Ageas Bowl, Hampshire

Flood and Drainage Addendum

A Flood Risk Assessment (FRA) for the proposed development of the site at the Ageas Bowl (planning reference number F/22/93194) was provided by Andy Clay Consulting (ACC) in August 2022.

An updated FRA was provided in July 2023. The LPA are Eastleigh Borough Council (EBC) and the LLFA are Hampshire County Council (HCC). LPA and LLFA comments on the July 2023 FRA were received in November 2023.

Figure 1 – Sections of Pipe Identified by the LLFA

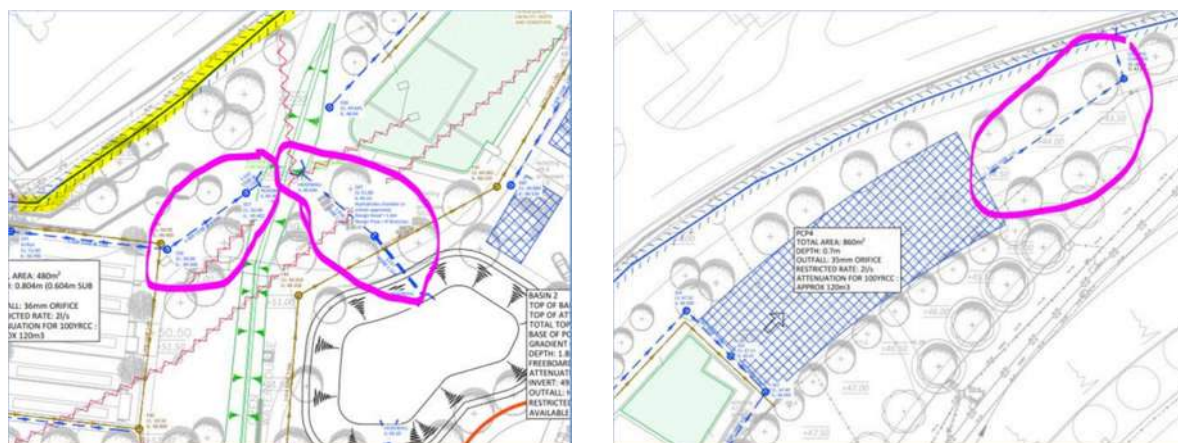
There are three sections of pipe within the surface water drainage strategy that the LLFA have identified and asked if they could instead be open drainage channels, as shown in **Figure 1**.

Given the requirement to provide 1:3 bank side slopes and with the depth of these pipes, this would require a wide grading to be included either side of any potential open flow channel. This would result in the loss of an area of accessible public open space where benches are currently proposed.

We do not therefore feel that this is viable and the best overall solution for the proposed development.

Figure 2 – Section of Pipe Identified by the LLFA

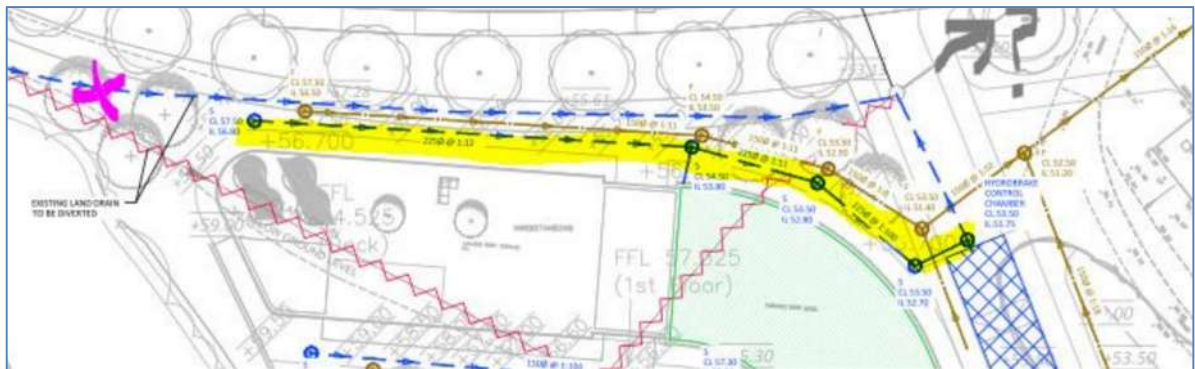
The LLFA make reference to a drainage pipe which they highlighted in yellow on **Figure 2**, and advise that this is a new surface water drain but that it does not pass through any form of filtration.

The LLFA also advise that it was unclear where the surface water pipe marked with a pink X is from. The annotation on the drainage plan clarifies this (as shown on **Figure 2**). It is an existing land drain that is to be diverted, but with the lower section continuing to drain as it does at present (i.e. into the lakes).

Drainage from the residential home discharges to a 600mm diameter pipe and then drains north-east towards the lakes, as described above. The lakes would therefore provide additional biodiversity benefit and natural filtration. We would also suggest that rain gardens could be incorporated into the building design, at detailed design stage, to provide additional biodiversity benefit and natural filtration.

Northern area of residential parcel (drainage strategy sheets 2, 1)

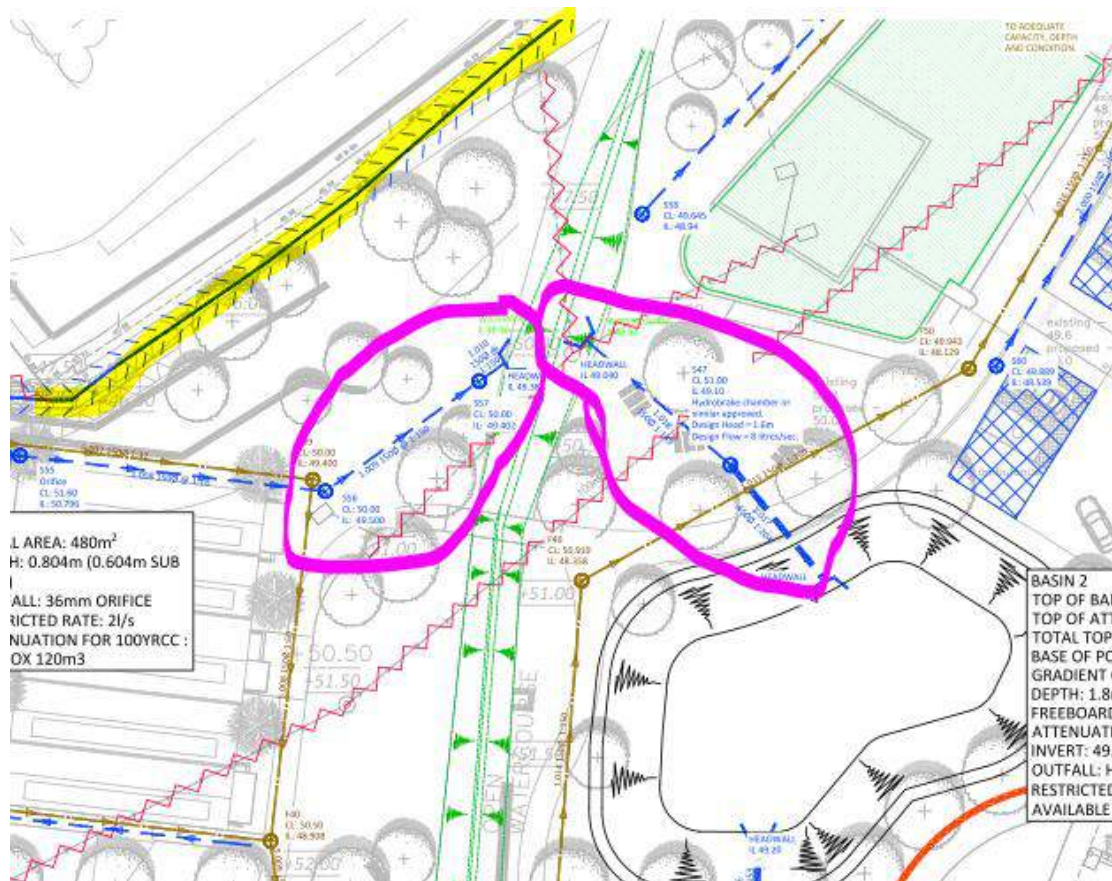
The majority of run off from this area will pass through one attenuation basin (Basin 2) before being discharged into the realigned Telegraph Brook.

Run off from the remainder of the area will pass through the pervious paving of the car park of a block of flats prior to discharge to the realigned Telegraph Brook.

Provided both the attenuation basin and pervious paving are designed to function effectively to filter all of the receiving surface water runoff, then this satisfies the SuDS manual criteria regarding WQ. However, EBC's Policy DM7 requires a further two forms of treatment of the surface water prior to discharge from the site (three forms in total) which previously has been agreed to be provided through the modification of the existing downstream ponds/ lakes. These modifications must form part of the drainage proposals and must be shown to be capable of acting as effective filtration components.

Wellbeing centre (drainage strategy sheet 5)

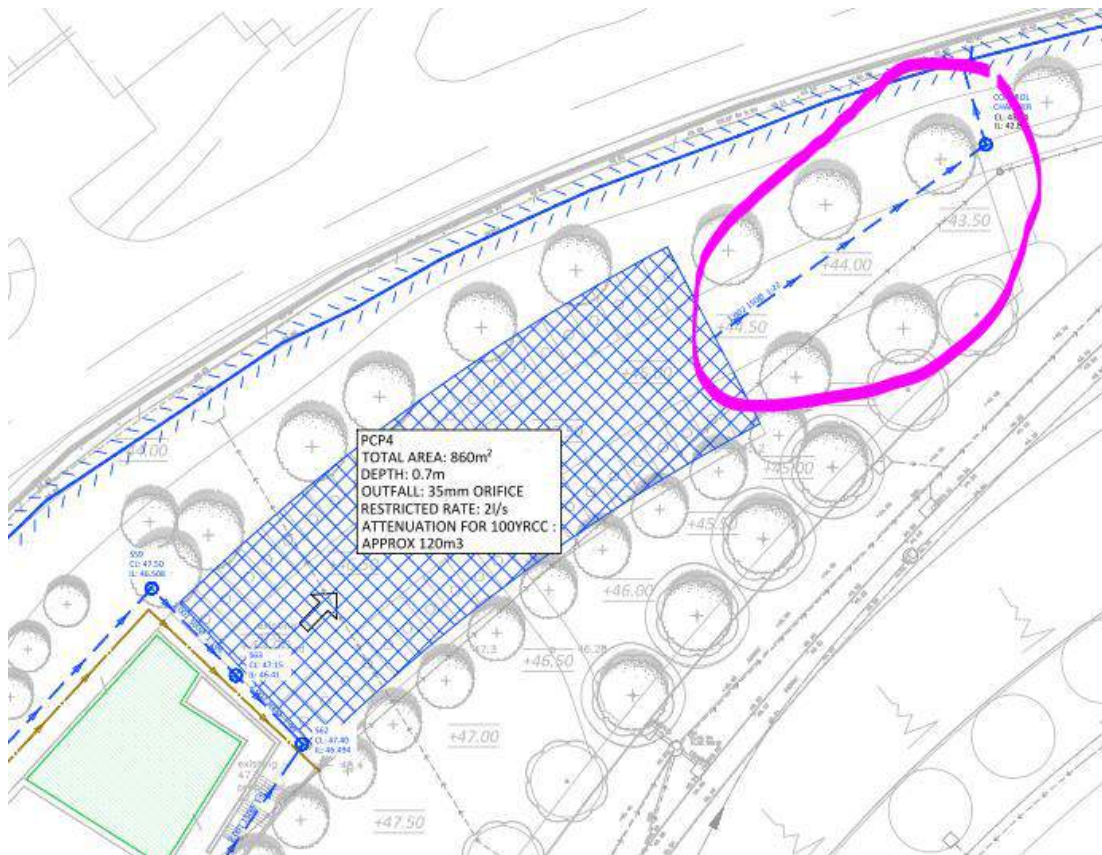
The green roof will provide good interception and run off will enter the adjacent pervious paving of the car park prior to discharge into the Telegraph Brook providing one form of filtration for the car park.

This level of filtration satisfies the SuDS manual criteria regarding WQ. However, EBC's Policy DM7 requires two further forms of treatment of the surface water prior to discharge from the site (three forms in total) which previously has been agreed to be provided through the modification of the existing downstream ponds/ lakes. These modifications must form part of the drainage proposals and must be shown to be capable of acting as effective filtration components.

The underground pipe network should be minimised as much as possible. Is there scope to change the pipe circled pink below to an open surface channel?

Residential home (drainage strategy sheet 9)

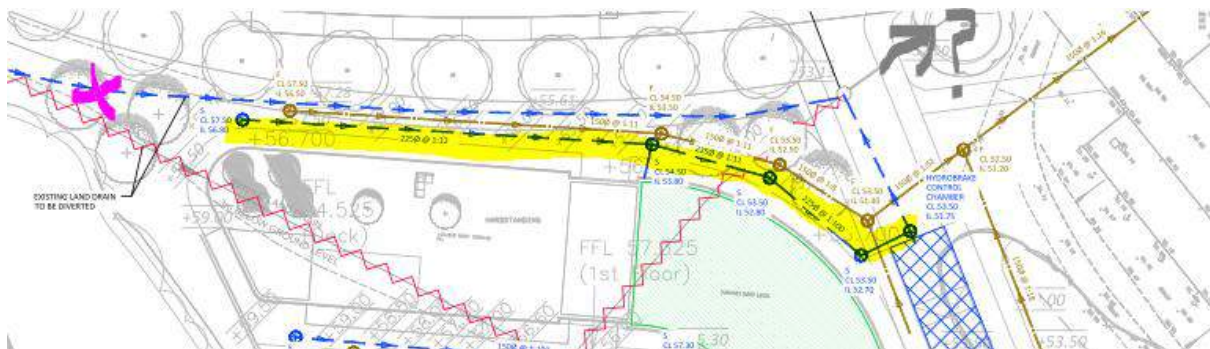
The green roof will provide good interception and the majority of the run-off from the roof and the surrounding area will enter the adjacent pervious paving of the car park prior to discharge into an existing surface water drain which continues in a north-east direction. This provides one form of filtration.
